Project	The Falls on Refugee Road	Addendum Number	3
Project Number	23446	Date	07/10/2025
To	All Bidders

This addendum contains changes to the requirements of the bidding Documents, Project Manual and Construction Drawings which have been issued to date. Such changes are to be incorporated into the Construction Documents and shall apply to the work in the same meaning and force as if they had been included in the original documents. Wherever this Addendum modifies a portion of a paragraph of the Project Manual or a portion of any Drawing, the remainder of the paragraph or Drawing shall remain in force.

PROGRESS DRAWING NOT FOR CONSTRUCTION	05/01/2025
	23446
	P103-B
	CD PROGRESS SET

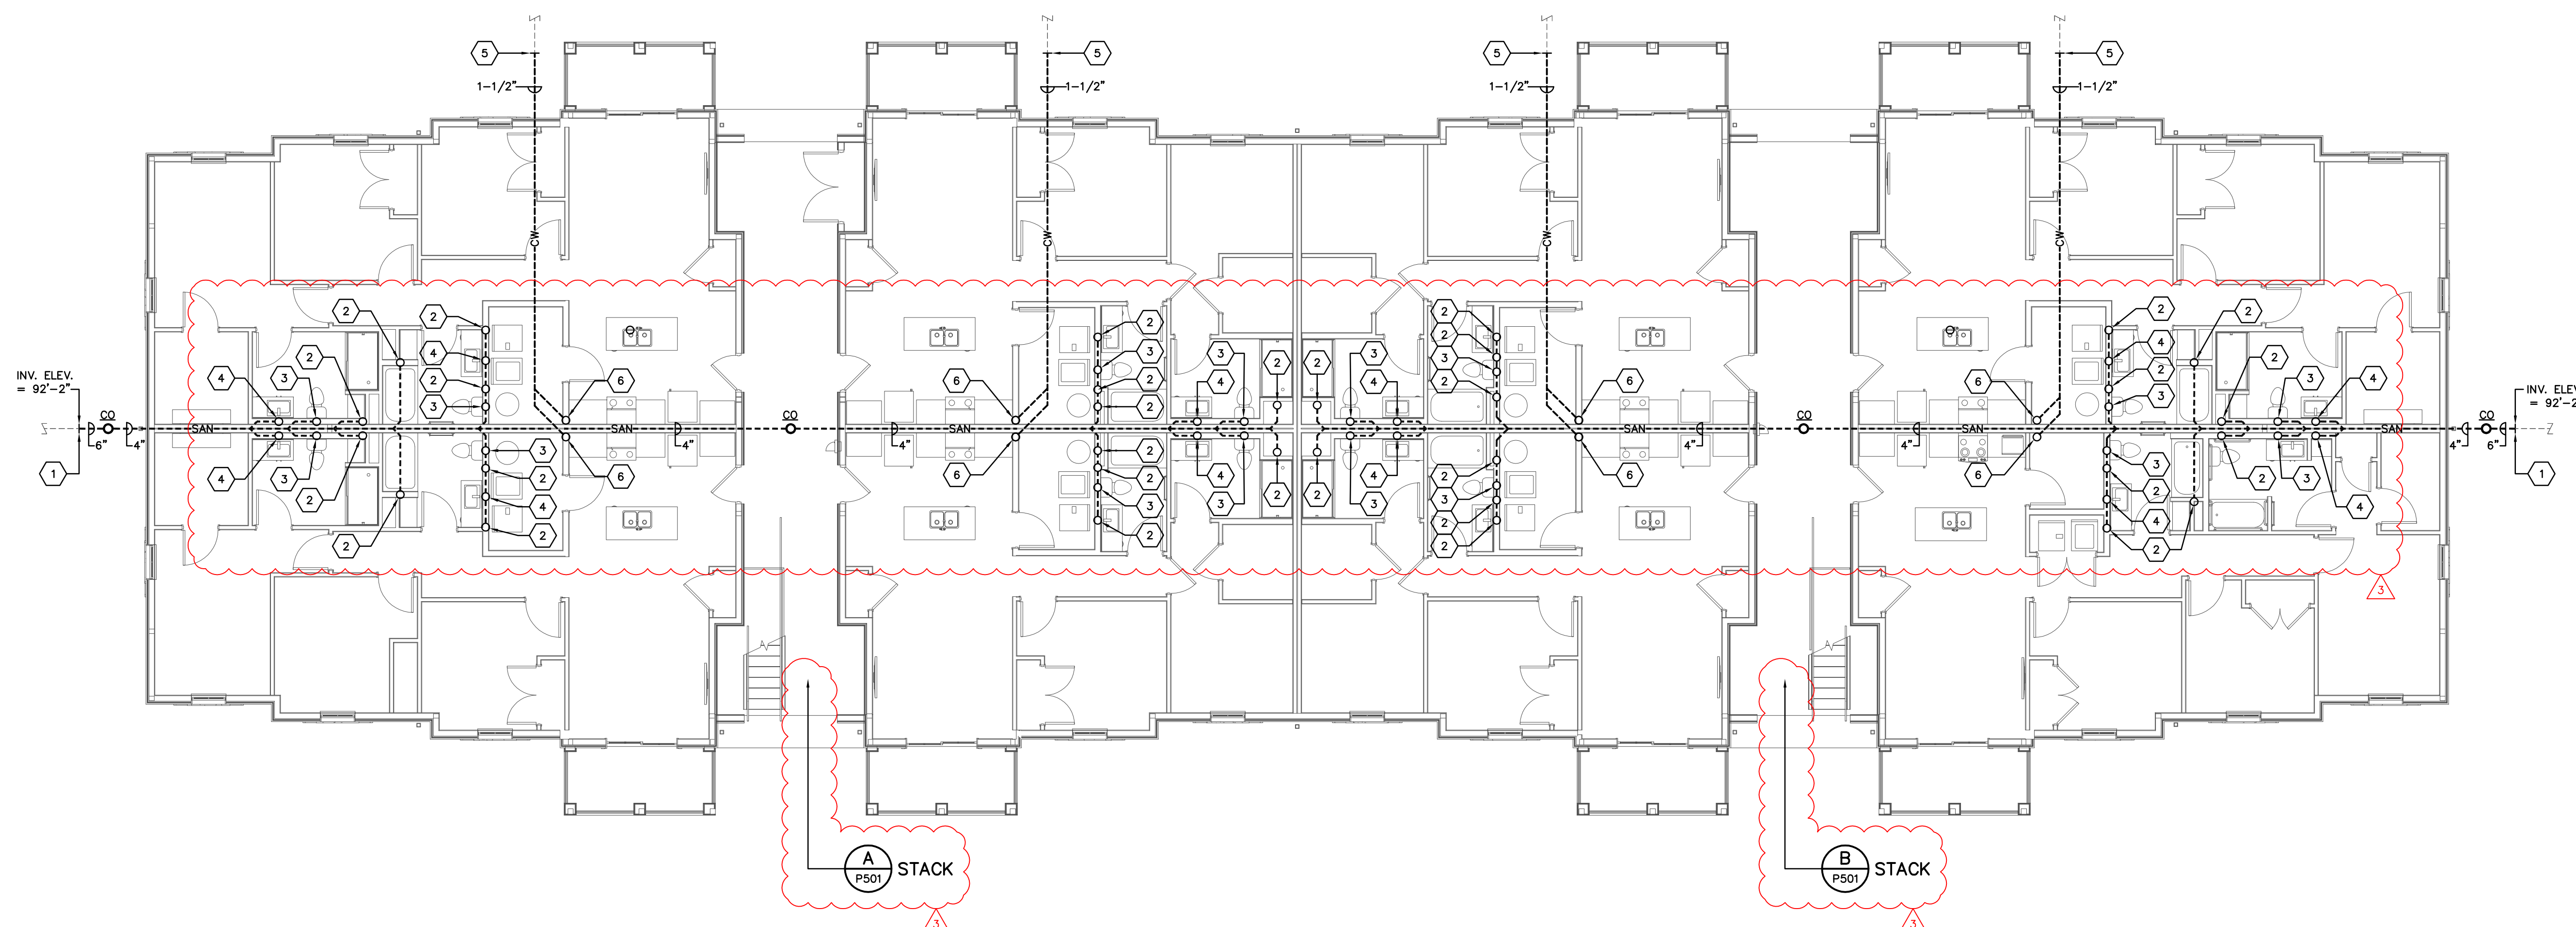
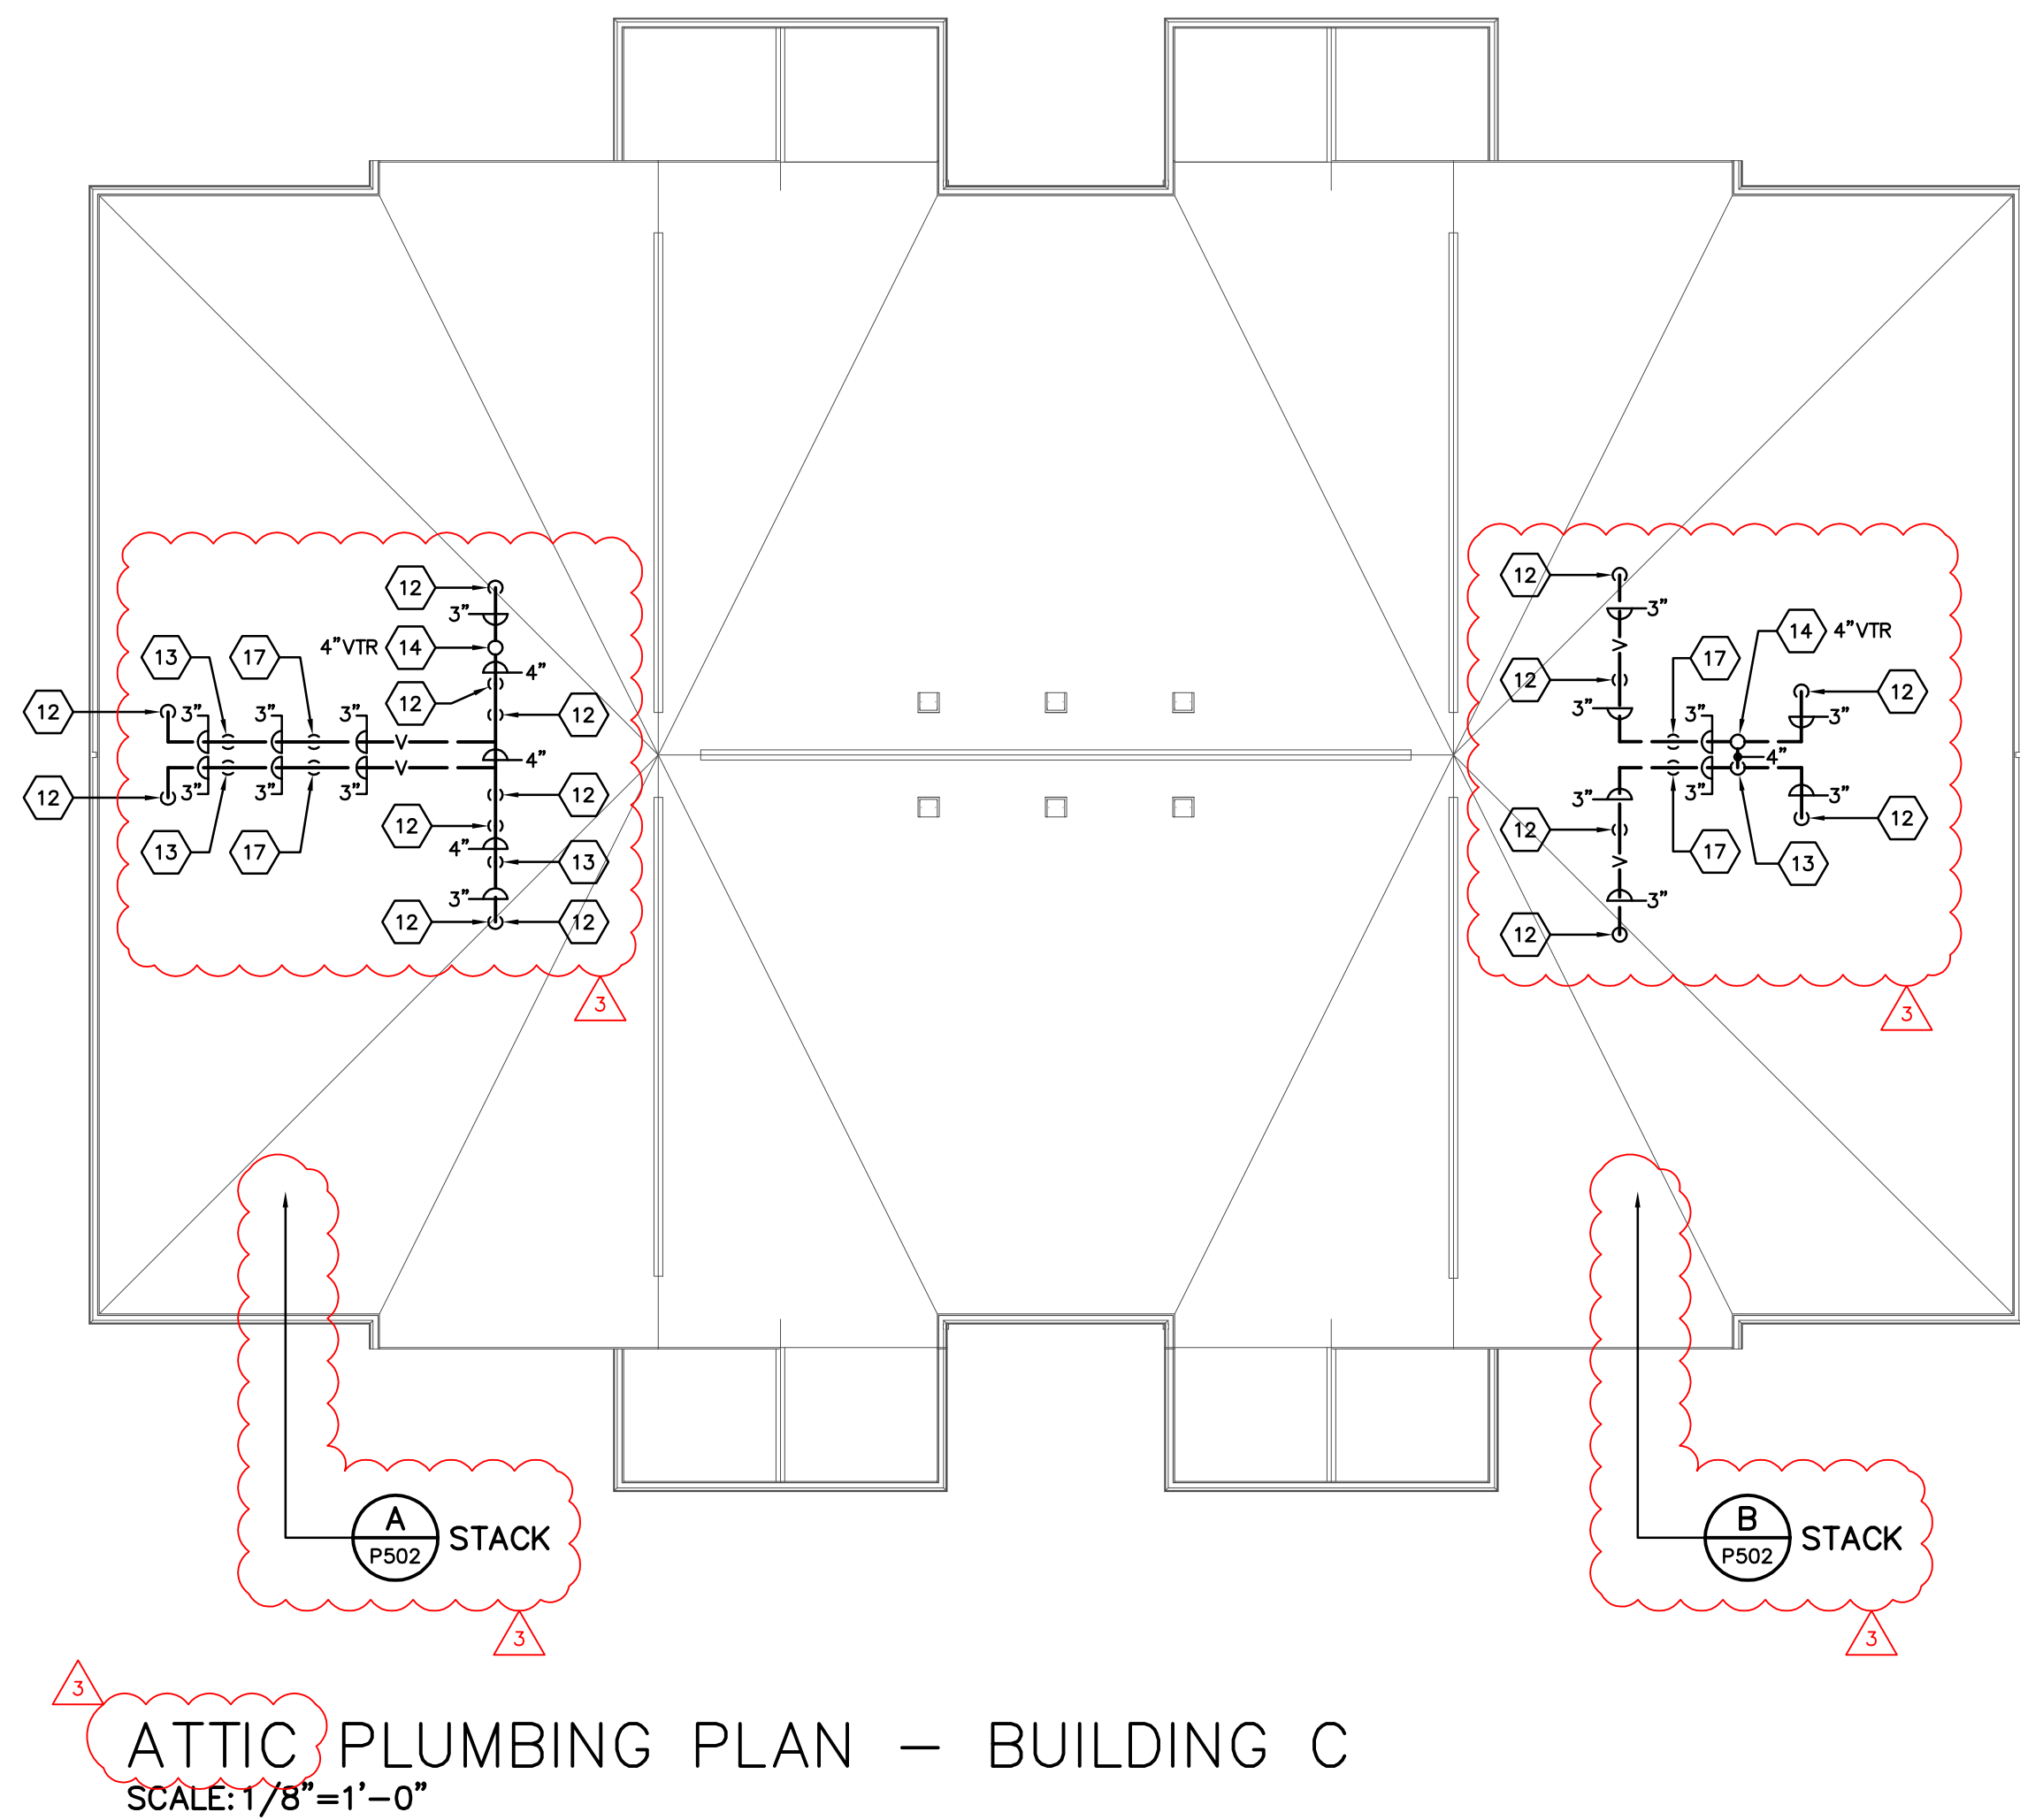
Sheet P103-B

1. Revised sanitary piping layout.
2. Revised Coded Notes 4 & 6.
3. Added stack diagram designations.
